# TECHNICAL SERVICE BULLETIN

## Illuminated MIL And/Or Powertrain Malfunction (Wrench) Indicator With Various Diagnostic Trouble Codes (DTCs)

**25-2385**

Ford 2022 e-Transit
------------------------

Figure 1

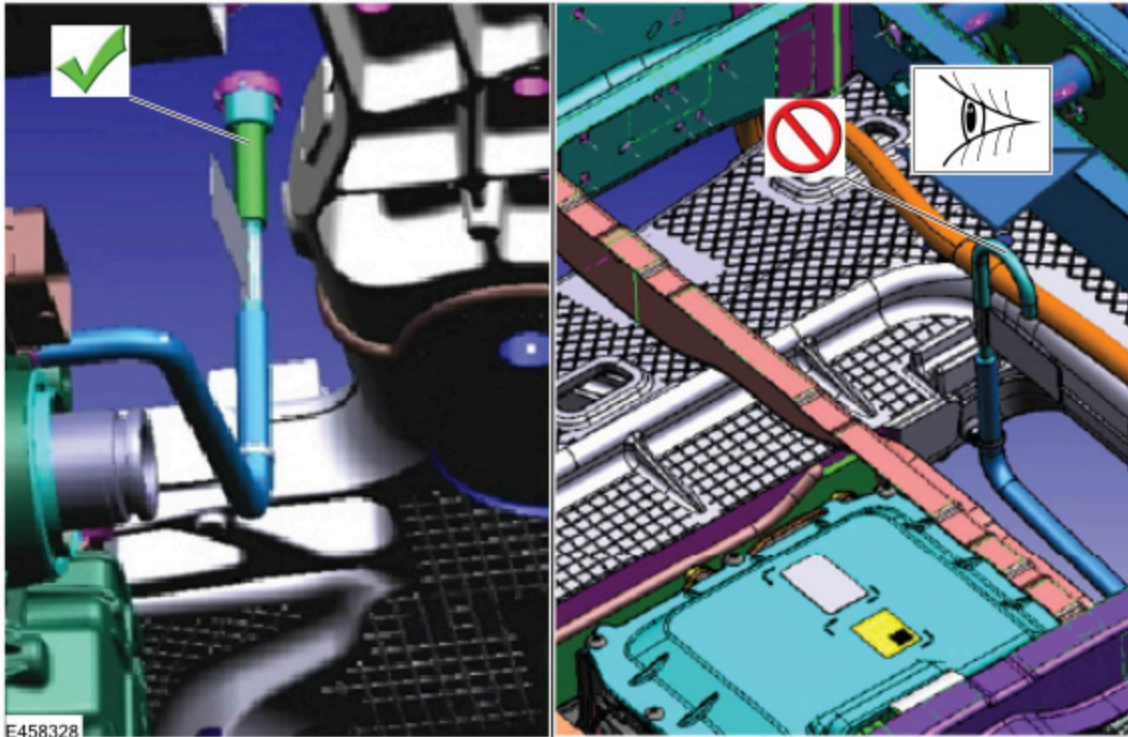
- Illuminated MIL and/or illuminated powertrain malfunction (wrench) indicator with DTCs P0711, P0A2B, P0A2D, P0A2C, P0712, P0713 stored in the SOBDMC.
- DTCs P0AA6, P1A10 stored in the IPC
- Equipped with early design vent assembly attached to rear electric drive assembly. Refer to Figure 1.

1. Raise vehicle to inspect the rear electric drive assembly unit vent. Refer to WSM, Section 100-02 > Jacking and Lifting.
2. Is the vehicle equipped with the rear electric drive assembly vent hose as shown in the image with the green check mark in Figure 1?

- (1). Yes - proceed to Step 4.
  - (2). No - proceed to Step 3.
3. Remove and discard the vent tube assembly and replace with updated part.
  4. Perform the "Drive Assembly Oil Draining and Filling". Refer to WSM, Section 302-02 > General Procedures.
  5. Clear DTCs.
